Pender County Planning Board Meeting
July 7, 2009
7:00 p.m.

PLANNING STAFF REPORT Avendale Planning Board Hearing

PLANNING STAFF REPORT
Schoolview Major Subdivision (formerly Scott Gerow Subdivision)
Planning Board Hearing

REVISED MASTER PLAN FOR
AVENDALE

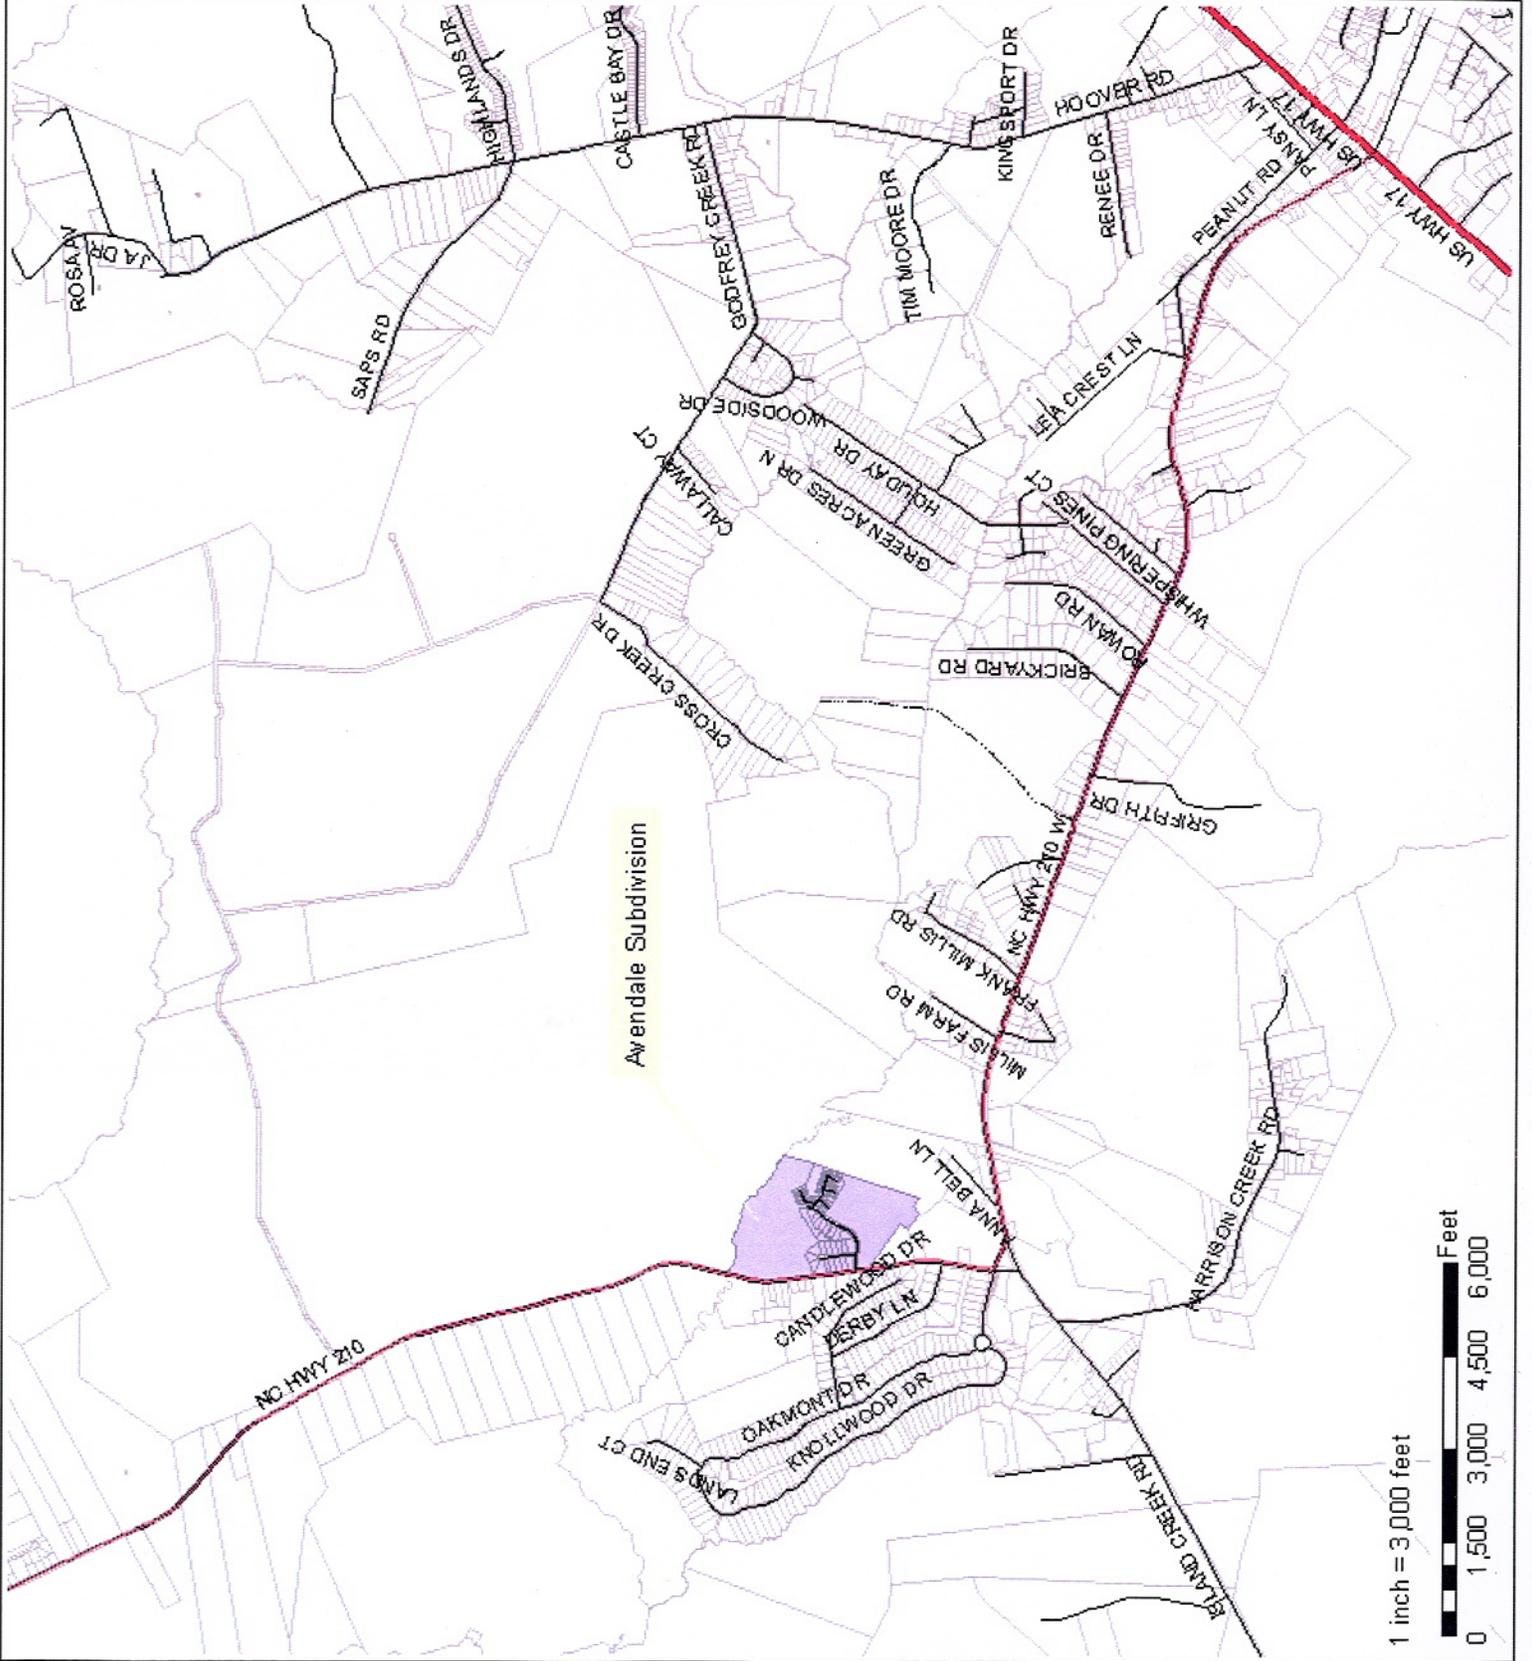
The applicant is proposing to add an additional spine road along with three connecting roads to accommodate the additional single family home sites, this provides for good interconnection throughout this portion of the

development. Also, the additional spine road has been stubbed for access to any future development adjacent to this property.

The amended master plan **does not reduce the overall density or open space requirements**. The decrease in town home sites will shift the density in to smaller, single-family home sites, as represented along the southeast portion of the development.

SCHOOLVIEW SUBDIVISION

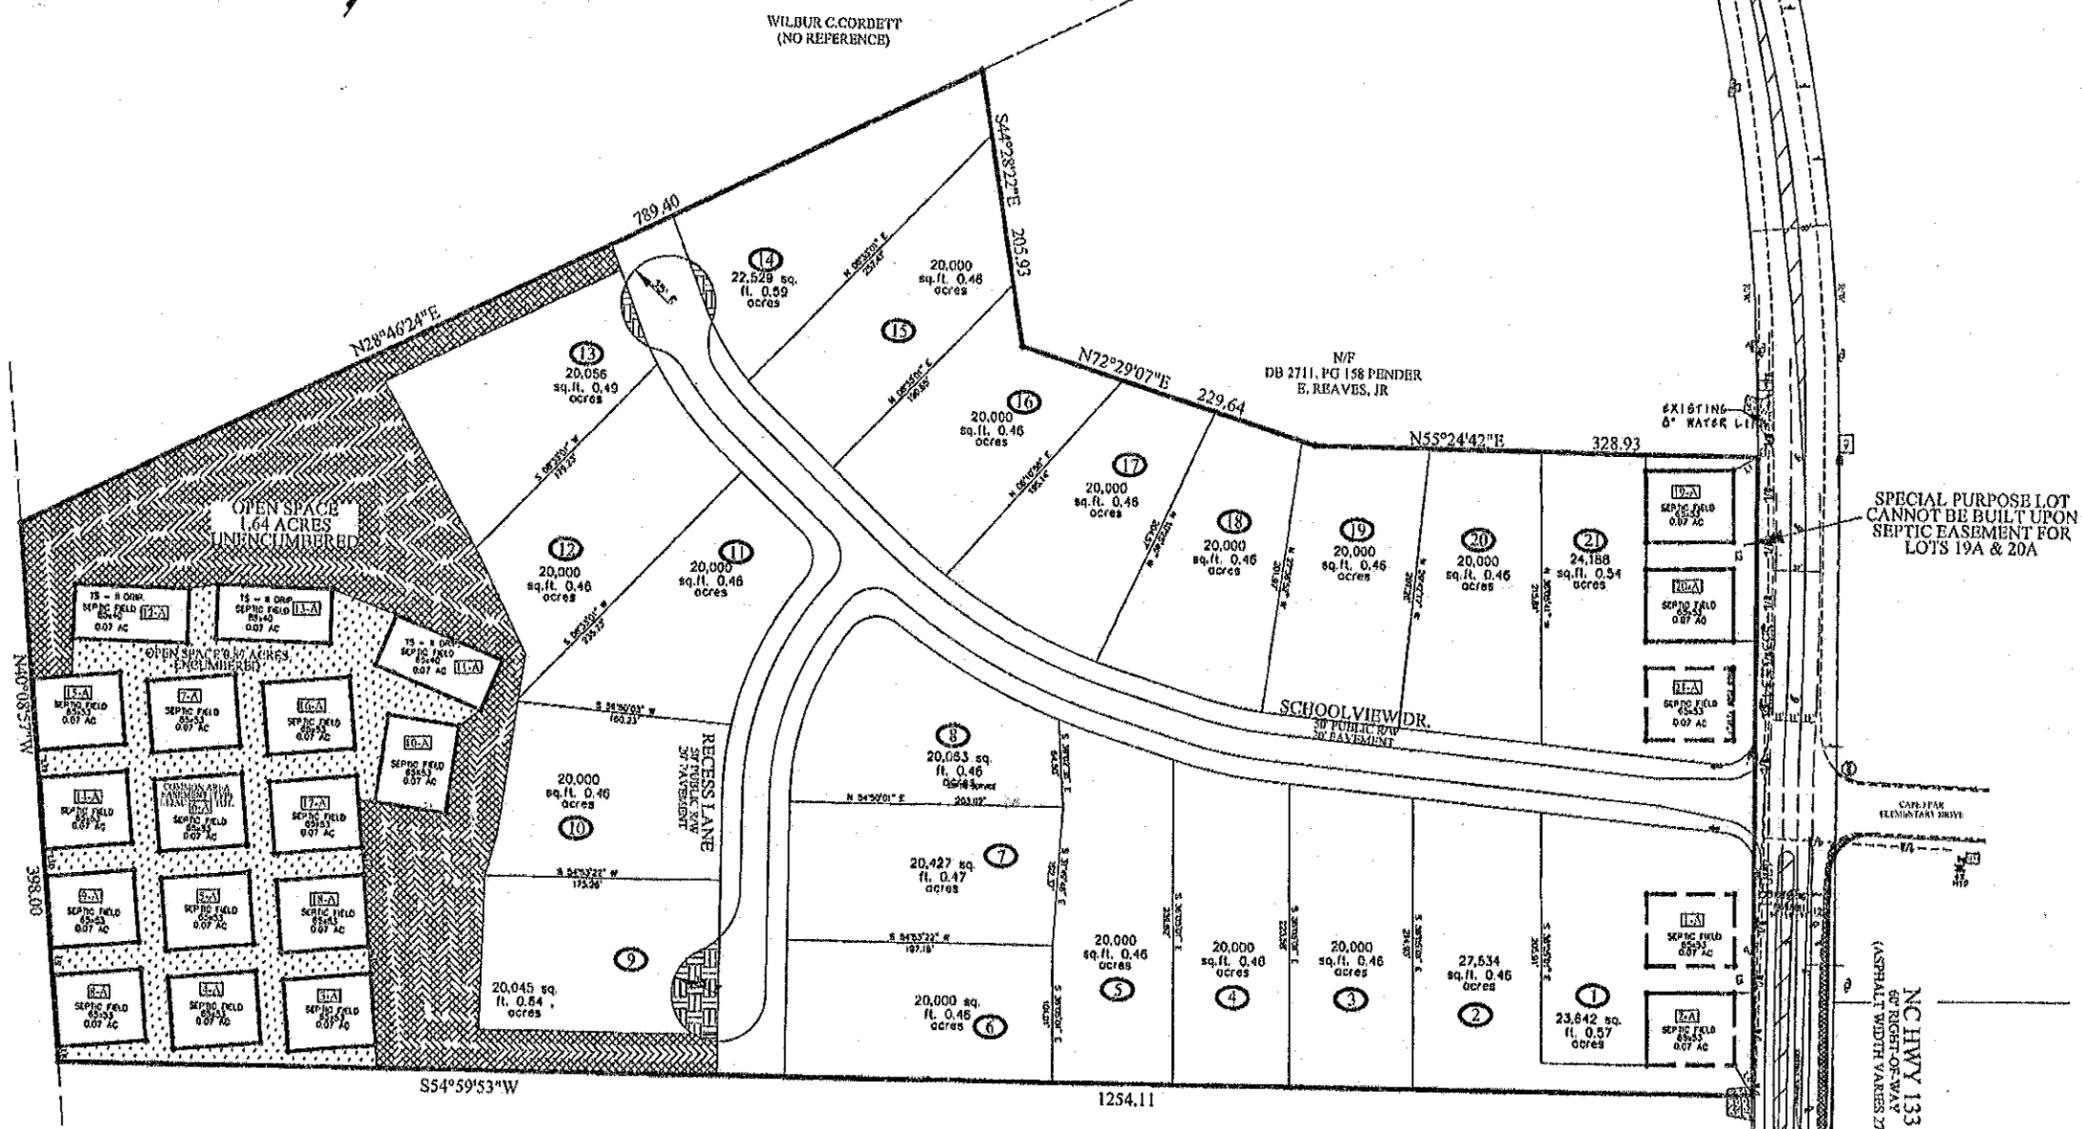
The attached Preliminary Plan now shows the drain fields for lot 2 and 21 to be connected and a part of those lots. The offsite areas for lots 19 and 20 are shown to be on a special purpose lot not a part of lot 21. Please consider these attachments for review at the next available Planning Board meeting.
